PFR-102 Title: FGS Harness Length Too Short

Assembly : FGS magnetometer	SubAssembly : Harness	
Component : Harness	Units Affected:	Units fixed:
Originator: Paul Turin	<input checked="" type="checkbox"/> <input checked="" type="checkbox"/> <input checked="" type="checkbox"/> <input checked="" type="checkbox"/> <input checked="" type="checkbox"/> <input checked="" type="checkbox"/>	<input checked="" type="checkbox"/> <input checked="" type="checkbox"/> <input checked="" type="checkbox"/> <input checked="" type="checkbox"/> <input checked="" type="checkbox"/> <input checked="" type="checkbox"/>
Organization: UCB	Date: 09/16/05	
Phone: 510-642-5289	Email : pturin@ssl.berkeley.edu

Photo 1

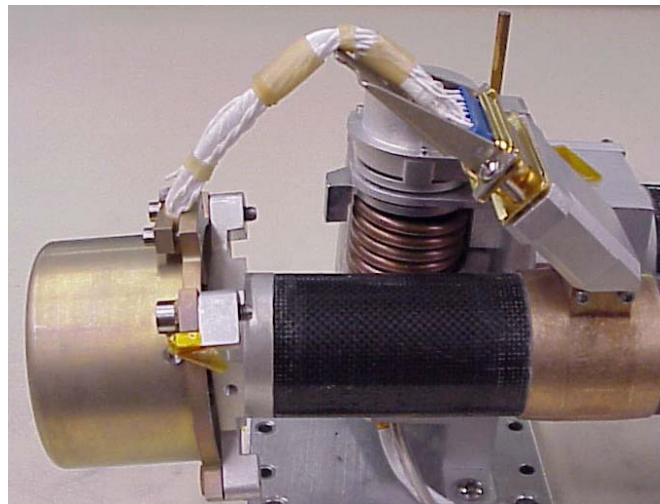
The FGB Boom was built to fit the FGS STM (Structural Test model) supplied by the FGM team. When the flight FGS units were installed on the FM2&3 FGBs, it was discovered that the flight harnesses were 1-3/4" shorter than the STM harness. The harnesses were installed despite not fitting correctly, possibly damaging conductors. This resulted in the harnesses being pulled sharply over the connector backshell edge and where the harness exits the magnetometer (see photo 1). This is an unacceptable condition for flight as it is likely to cause harness damage.

Rather than sending the sensors back to Germany for longer harnesses, which would entail significant rework and retesting, it was decided to modify the harness connector backshell to provide a shorter path and appropriate curvature for the harness. The backshell sides were cut, the tray was bent to a 30 degree angle, and reinforcing clips were bonded over the cuts to strengthen the backshell (see photo 2). This reshaped the harness into an acceptable path (see photo 3). The FM2&3 harnesses have been inspected at the completion of the FM2&3 suite thermal vac test for any damage caused by the excessively sharp bends and none was found. All of the flight harnesses have had modified backshells installed, and have been overwrapped with Teflon tape for protection.
